S E R V I C E N O T E

HP 4948A In-Service Transmission Impairment Measuring Set

Measurement hang-up with Error Code 2000

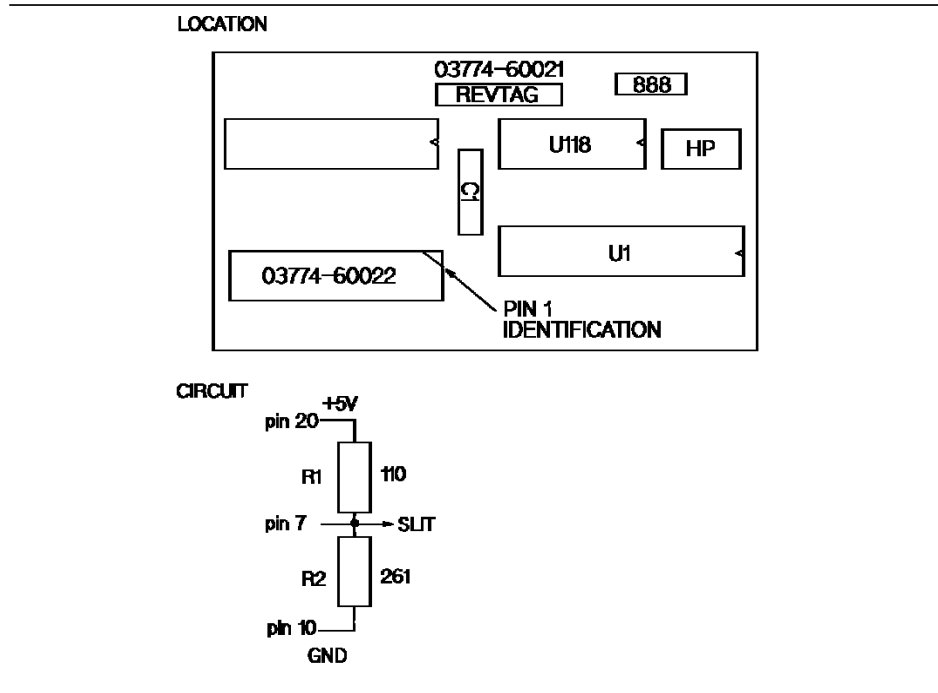
Reflections in clock distribution signal to Condition Multiplexer circuit of the Signal Processor Clock Signal (SLIT) can cause this problem. The signal has been improved by the addition of a termination network.

Add termination network part number 03774-60022 to the A9 piggy-back assembly 03774-60021. Note the network plugs into a spare 20 pin socket located on the piggy-back assembly. Orientation is indicated by chamfer at pin 1. See Figure below.
